STAFF RECOMMENDATION 3534 Richland Avenue Lot 21, Richland Hall Development January 16, 2019

Metropolitan Historic Zoning Commission
Sunnyside in Sevier Park
3000 Granny White Pike
Nashville, Tennessee 37204
Telephone: (615) 862-7970
Fax: (615) 862-7974

Description of Project: Revision to a previously approved application to construct a new single family infill with an attached garage at basement level.

Figure 2. Overall site plan for the 22 infill houses planned for the Richland-West End Neighborhood Conservation Zoning Overlay. The red box indicates the site currently under consideration.

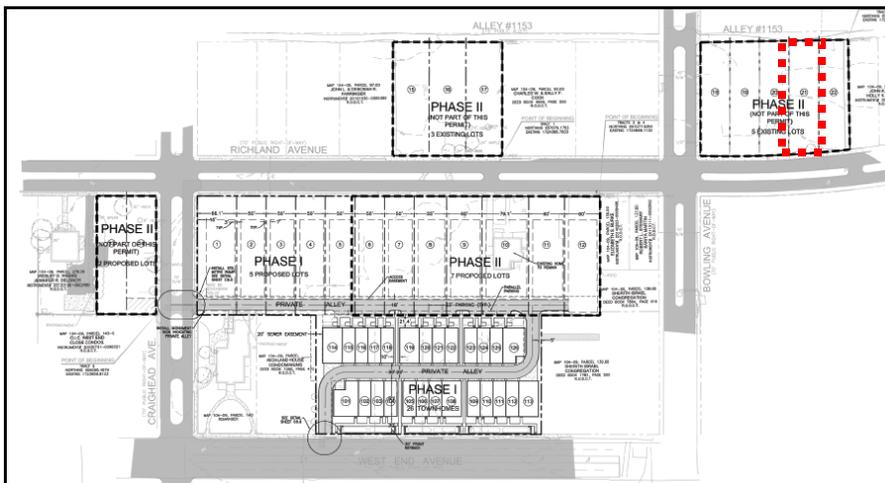
Setback & Rhythm of Spacing: This revision does not propose any changes to the setbacks or rhythm of spacing that were approved in December 2018 by the Commission.

1 FRONT ELEVATION
 1/8" = 1'-0"

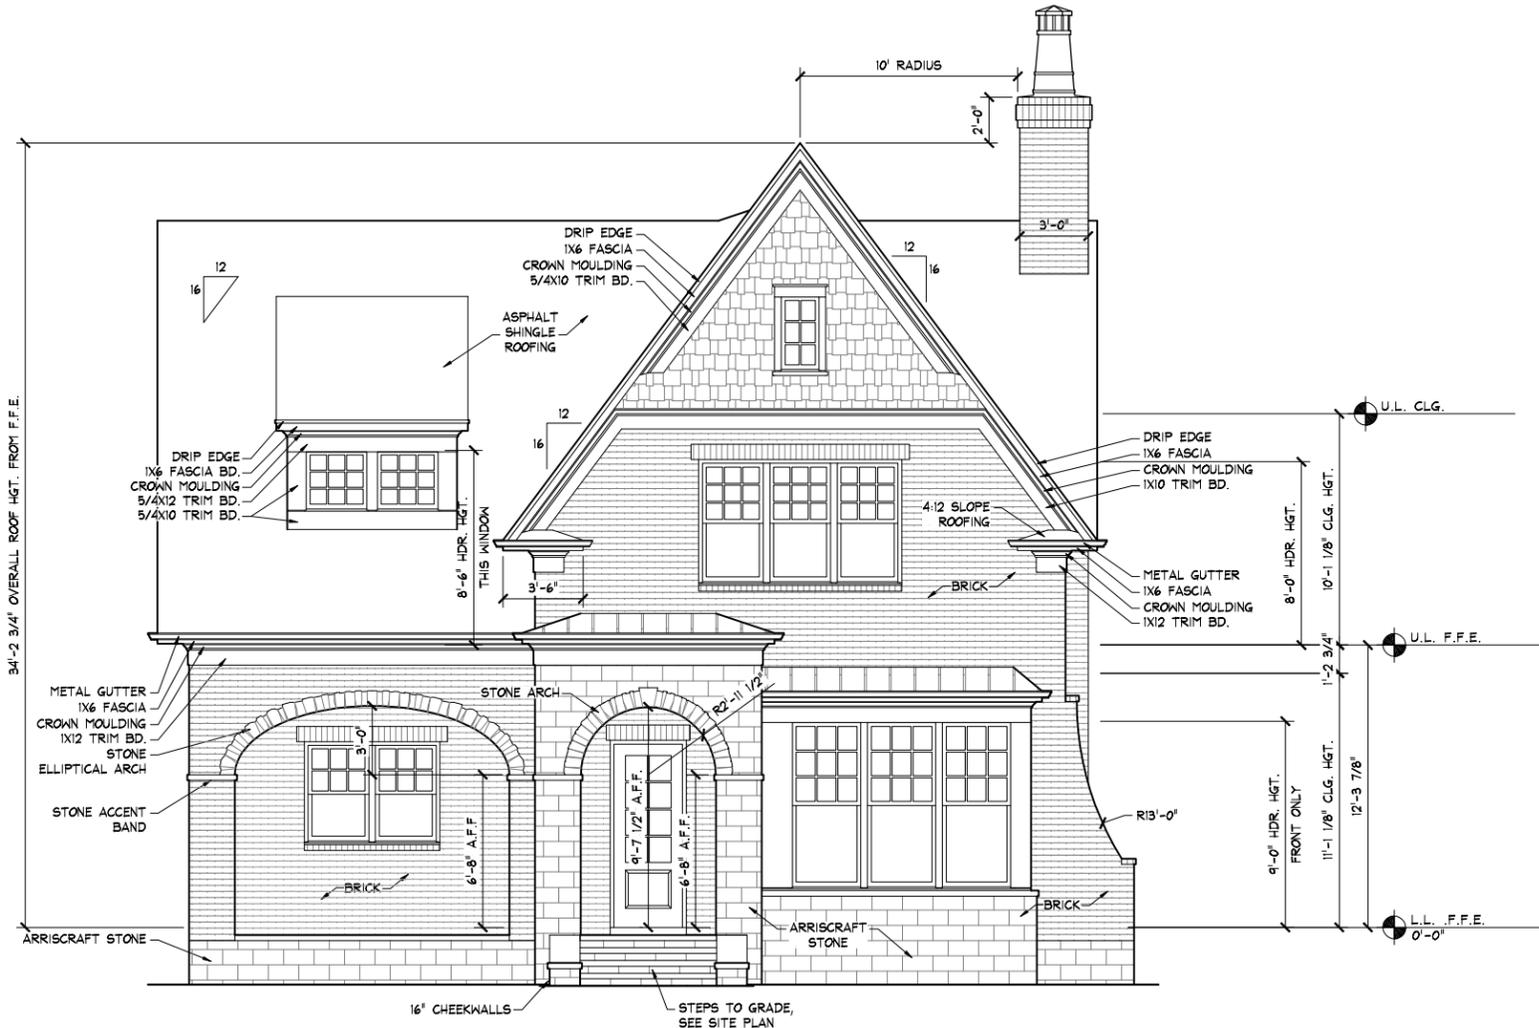
Materials: The proposed materials were approved by the Commission in December 2018. The only new materials as a part of the revision are fiber-cement shake shingles in the front gable field and a secondary roofing material on the front porch entry and window bay. Staff should review and approve the secondary roofing material prior to purchase and installation.

2 RIGHT ELEVATION
 1/8" = 1'-0"

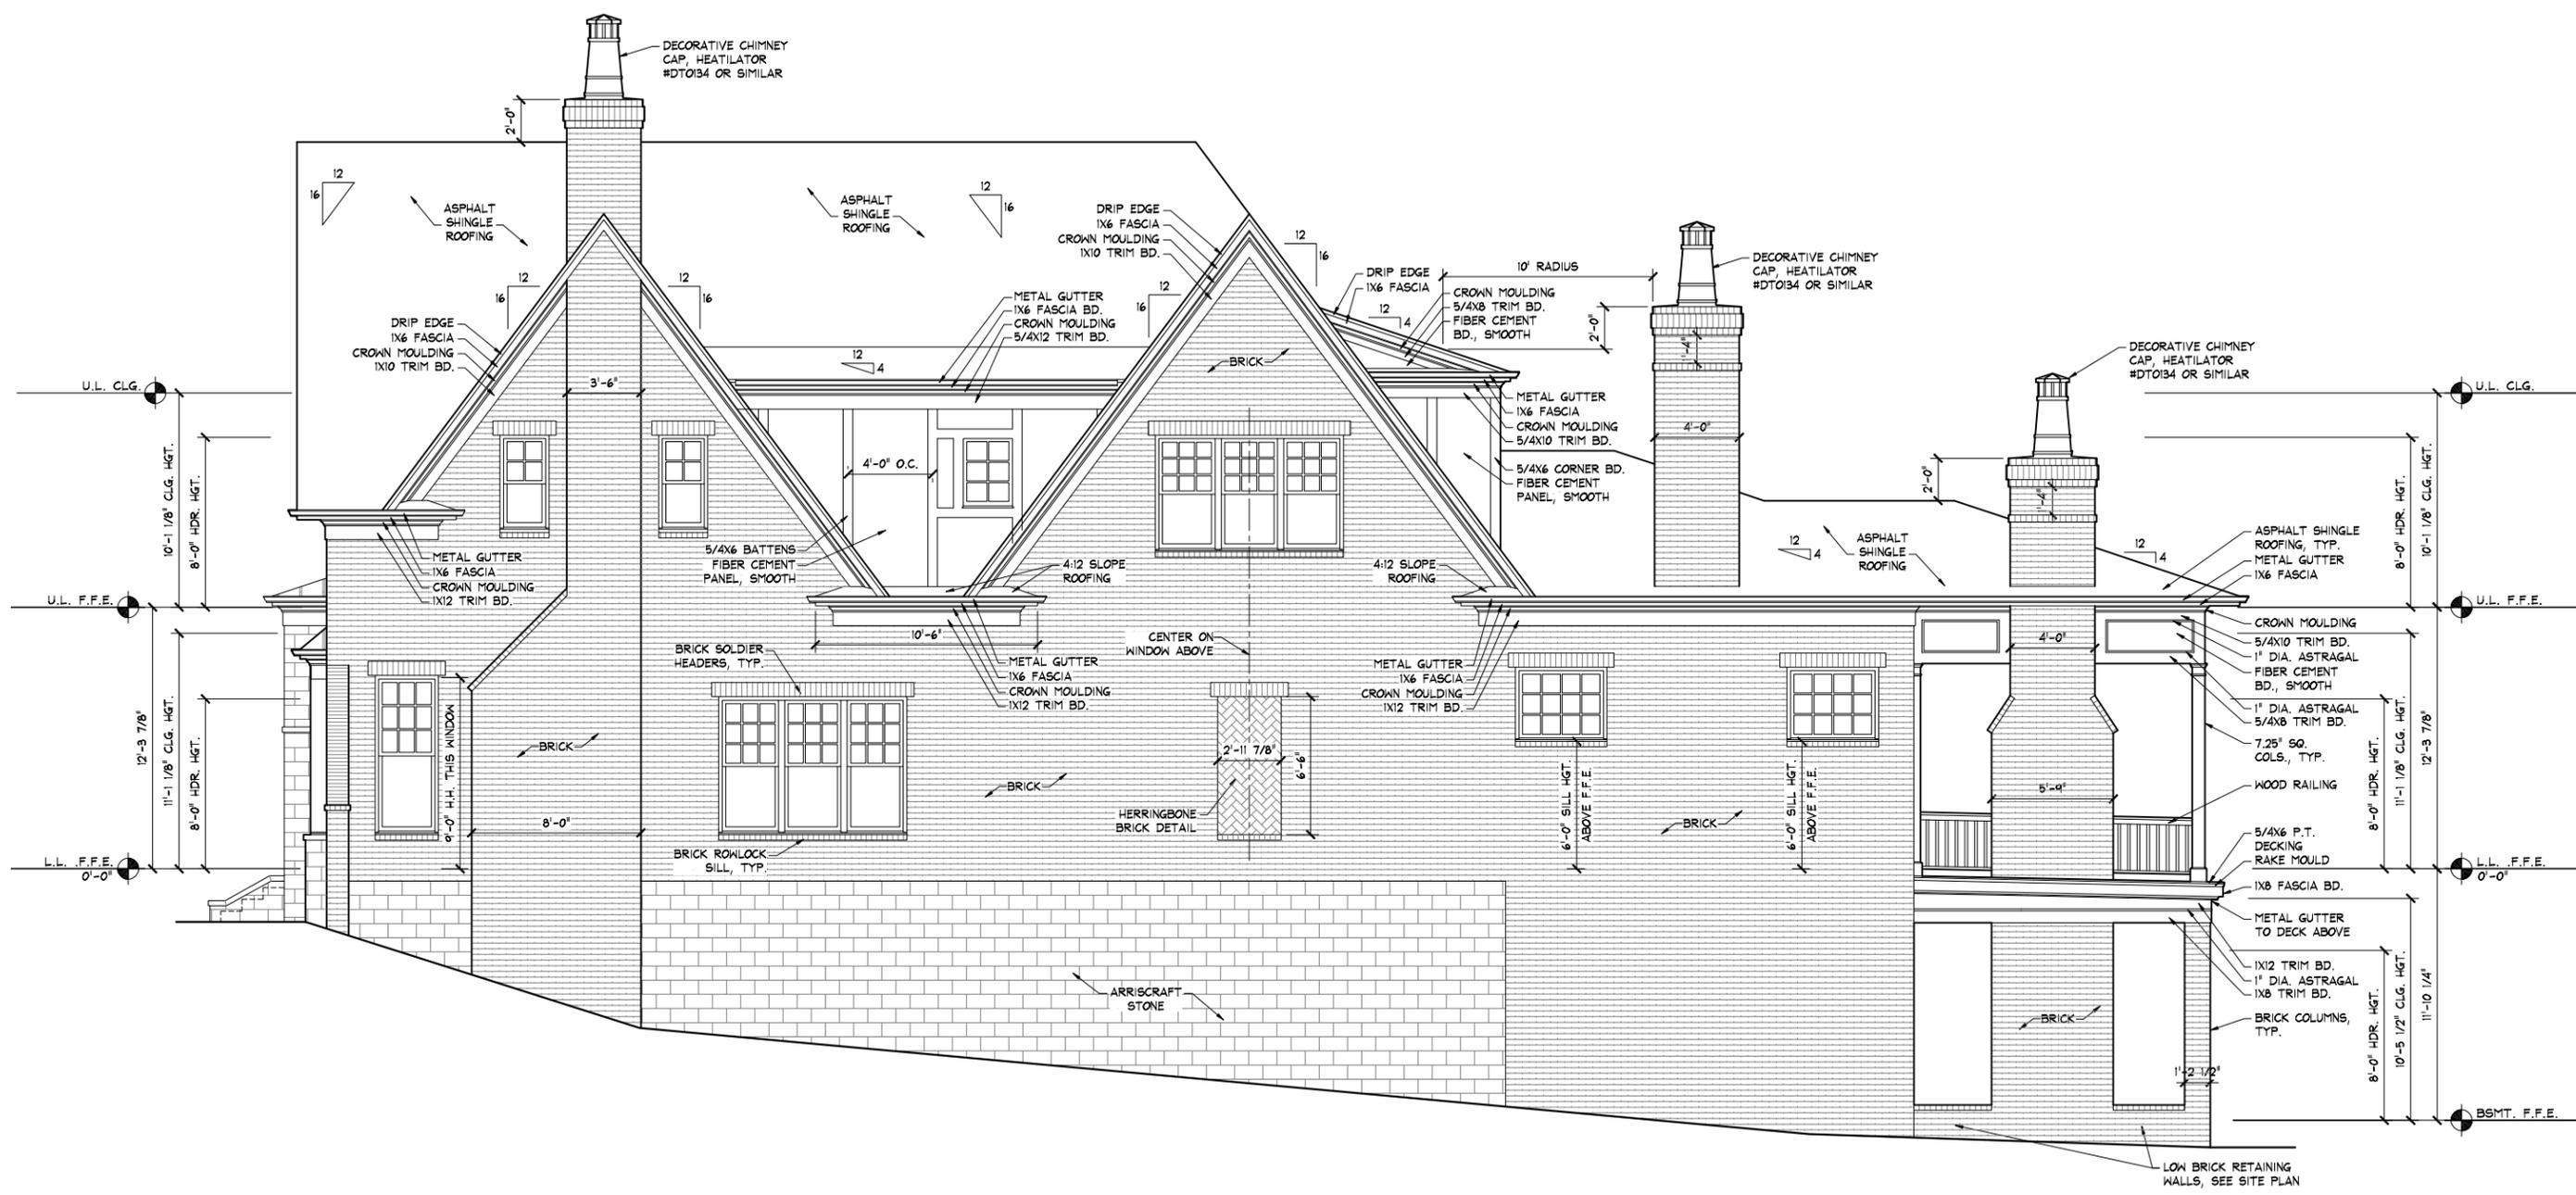
Figure 3. Right elevation.

Roof form: The roof form has not changed since the December 2018 approval. The primary difference is that the front-gabled form maintains a 16/12 pitch along the right elevation, but transitions to a much shallower 4/12 pitch along the left elevation. Staff finds that the revised roof forms are appropriate for an infill house in the overlay, and finds that the roof forms meet Section II.B.1.e. of the design guidelines.
